SUBJECT: ISSUANCE OF AMENDMENT NOS. 168, 168, AND 165 TO FACILITY OPERATING
LICENSES DPR-38, DPR-47, and DPR-55 - OCONEE NUCLEAR STATION,
UNITS 1, 2, AND 3 (TACS 65768/65769/65770)

SAFETY EVALUATION BY THE OFFICE OF NUCLEAR REACTOR REGULATION
RELATED TO AMENDMENT NO.168 TO FACILITY OPERATING LICENSE DPR-38

OCONEE NUCLEAR STATION, UNITS 1, 2 AND 3

Oconee Nuclear Station
Figure 3.5.2-16

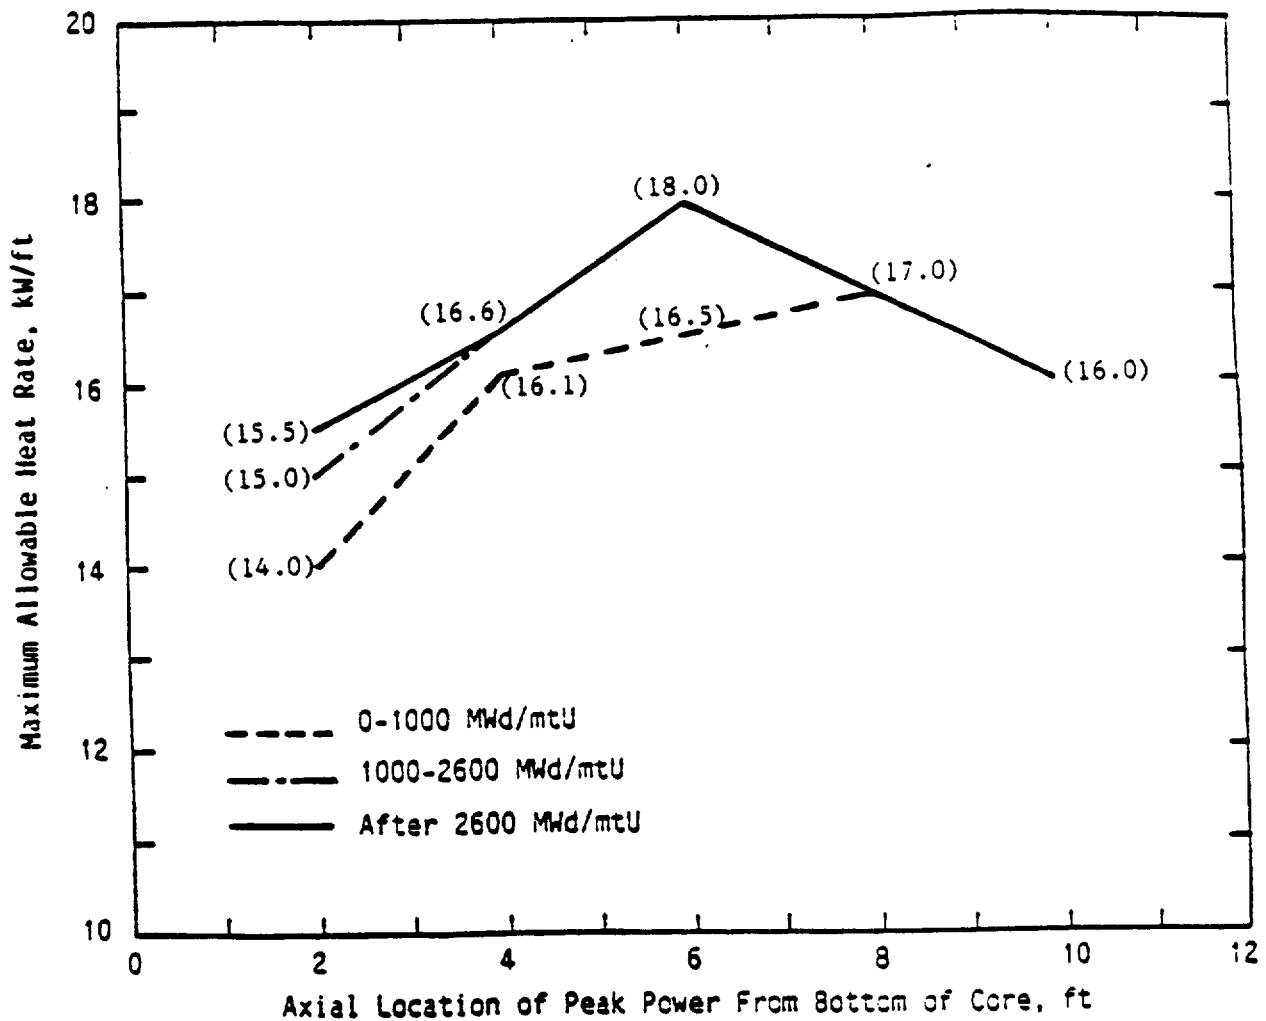
The proposed amendments would revise the LOCA-Limited Maximum Allowable Linear Heat Rate (Figure 3.5.2-16). These revisions would reflect NUREG-0630, Cladding Swelling and Rupture Models for LOCA Analysis and Babcock and Wilcox (B&W) Owners Group Topical Report BAW-1915P, Bounding Analytical Assessment of NUREG-0630 models of LOCA kilowatt-per-foot limits with use of FLECSET.

BAW-1915P and BAW-10104, Revision 5 have been reviewed by the Commission and approved on October 5 and December 27, 1987 (References 3 and 4). These reports provide the technical basis for these revisions. The models addressed in these reports are used to determine the LOCA-Limited Maximum Allowable LHR. The proposed revision to Figure 3.5.2-16 reflects application of the new models.

The proposed TS revisions are to update the LOCA-Limited Maximum Allowable Linear Heat Rates reflecting the effects of the NUREG-0630 models and the analytical results with use of the FLECSET correlation (Reference 5). We have reviewed the proposed TS changes and find that the proposed LOCA-Limited Maximum Allowable Linear Heat Rates are consistent with the calculated results presented in Table 3.2 of Reference 5, which had previously been approved by the Commission (Ref. 3) for licensing applications for the B&W lowered loop 15x15 fuel assembly plants including the Oconee plants. B&W performed the large break LOCA analyses to support the request of the TS revisions by using the modified ECCS Evaluation Model as described in the B&W topical report BAW-10104, Revision 5. On December 27, 1987, we generically approved the topical report BAW-10104, Revision 5. The staff also found the plant specific application of the B&W topical report BAW-10104, Revision 5 to the Oconee plants to be adequate and acceptable. Therefore, we conclude that the proposed TS revisions are acceptable.

Replace the following page of the Appendix "A" Technical Specifications with the enclosed page. The revised page is identified by Amendment number and contains vertical lines indicating the areas of change.
